# Access Compliance Report

## Public Rights-of-Way

### (Curb Ramps)

Intersection ID: 50904	Main Street: KARRAS_COMMONS_WY	Cross Street: TILLEY_MORRIS_RD	Location: NE
ADA ID: 16069CE8FDDF	Ramp Type: Perp	Initial Pass/Fail: Fail	Overall Compliance: No
		Severity Score: 8.75

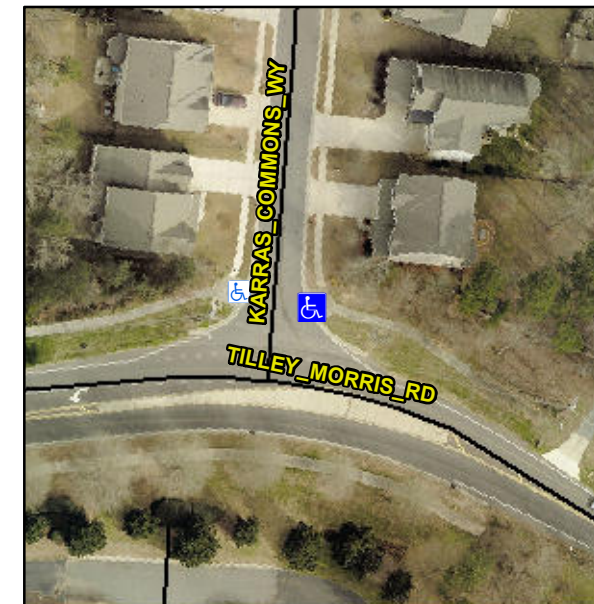
**Not Found, R304.5.1**

Compliance	Description	Data	Compliance	Description	Data
N/A	Ramp Length (in)	123.0	Yes	Ramp Slope (%)	6.1
No	Ramp Width (in)	39.0	Yes	Ramp XSlope (%)	1.3
N/A	Flare Type LT	N/A	N/A	Flare Type RT	N/A
N/A	Flare Slope LT (%)	N/A	N/A	Flare Slope RT (%)	N/A
N/A	Flare Traversable LT?	N/A	N/A	Flare Traversable RT?	N/A
N/A	Landing Length (in)	N/A	N/A	DWS Provided?	N/A
N/A	Landing Width (in)	N/A	N/A	DWS Contrast?	N/A
N/A	Landing Slope (%)	N/A	N/A	DWS Length (in)	N/A
N/A	Landing X Slope (%)	N/A	N/A	DWS Full Width?	N/A
N/A	Landing Curb? (Y/N)	N/A	N/A	DWS Offset (in)	N/A
N/A	Shared Landing?	N/A			
N/A	Gutter Ponding?	N/A	N/A	Gutter Slope (%)	N/A
N/A	Gutter Lip Ht (in)	N/A	N/A	Gutter X Slope (%)	N/A
N/A	Painted X Walk1?	No	N/A	Painted X Walk2?	N/A
	X Walk 1 Direction	To W		X Walk 2 Direction	N/A
N/A	X Walk 1 Width (in)	N/A	N/A	X Walk 2 Width (in)	N/A
	X Walk 1 Slope (%)	2.4		X Walk 2 Slope (%)	N/A
	X Walk 1 X Slope (%)	2.8		X Walk 2 X Slope (%)	N/A

**Remove & Replace Entire Ramp.**
